SOLBERG PIT - SITE PLAN

SECTION 21, TOWNSHIP 13 SOUTH, RANGE 64 WEST
OF THE 6TH P.M., EL PASO COUNTY, COLORADO

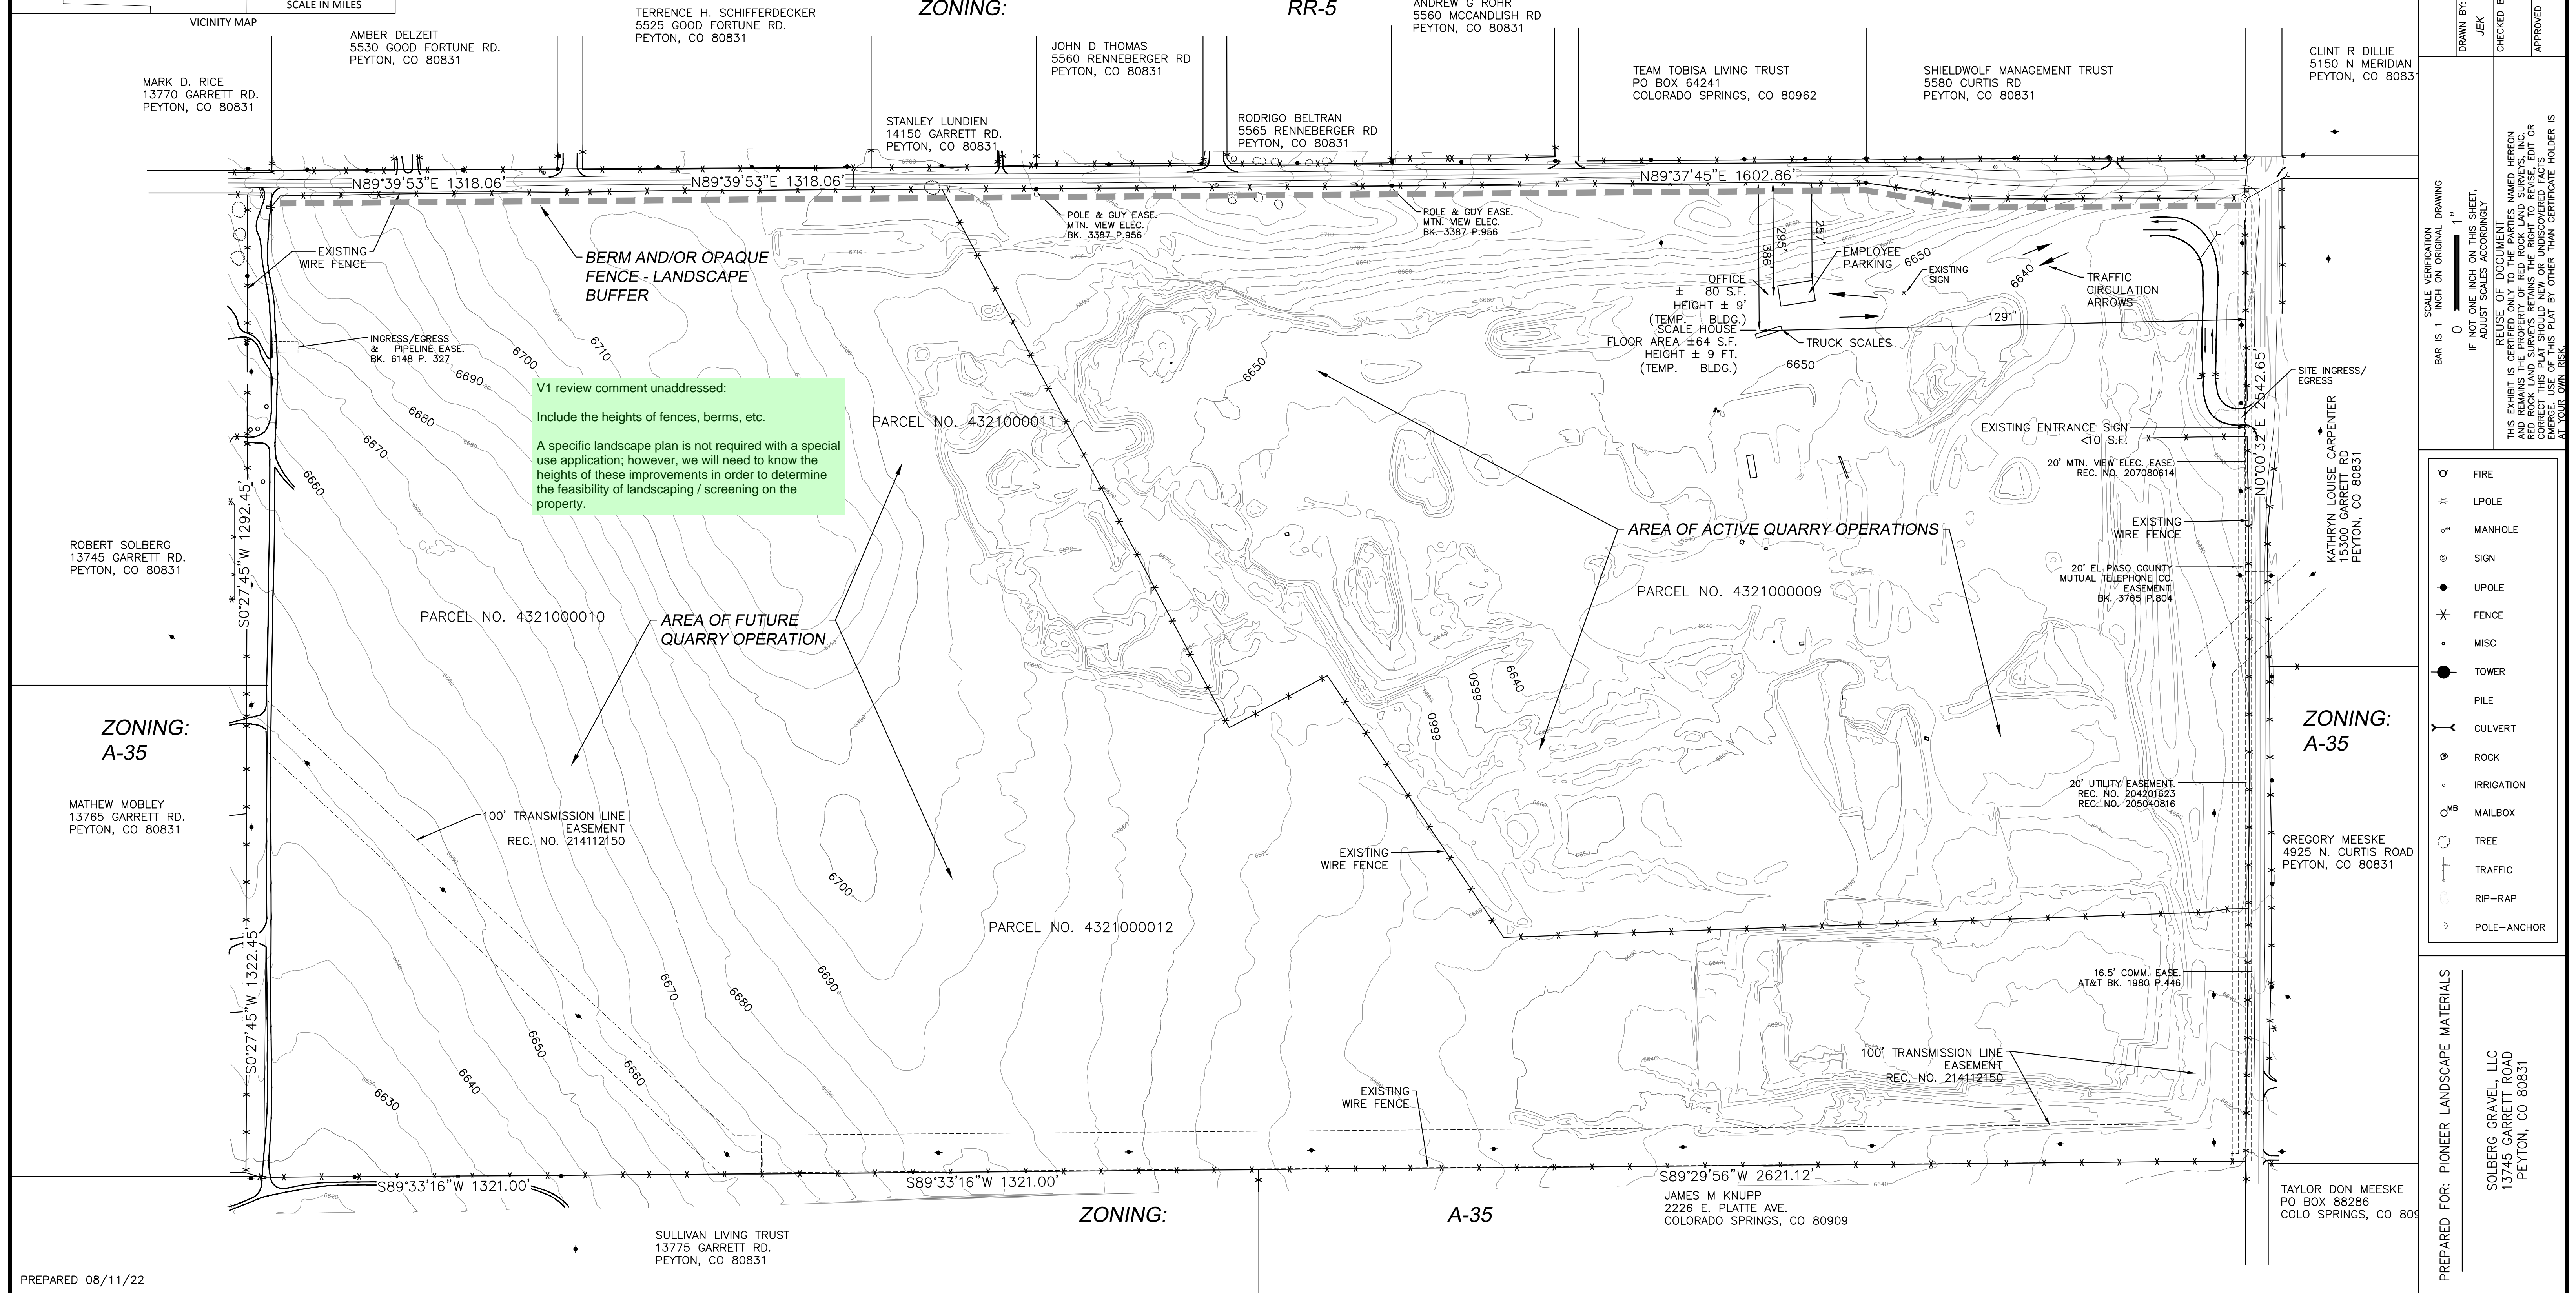
This note appears to be in conflict with the information depicted on the plan, which shows berms.

Remove this. Open space is not required component of this type of application and is not applicable here. However, landscaping will be required per the other comments so a calculation of the total site landscaping will be needed at the site development plan stage.

V1 review comment unaddressed:
 Include the heights of fences, berms, etc.
 A specific landscape plan is not required with a special use application; however, we will need to know the heights of these improvements in order to determine the feasibility of landscaping / screening on the property.

1. THERE ARE NO SIDEWALKS EXISTING OR PROPOSED ONSITE.
2. THERE ARE NO WALLS EXISTING OR PROPOSED ONSITE.
3. ~~THERE ARE NO BERMS ONSITE~~ HOWEVER OVERBURDEN AND TOPSOIL STORAGE PILES ON THE EAST AND SOUTHEAST PERIMETER SERVE AS NOISE AND VISUAL BARRIER.
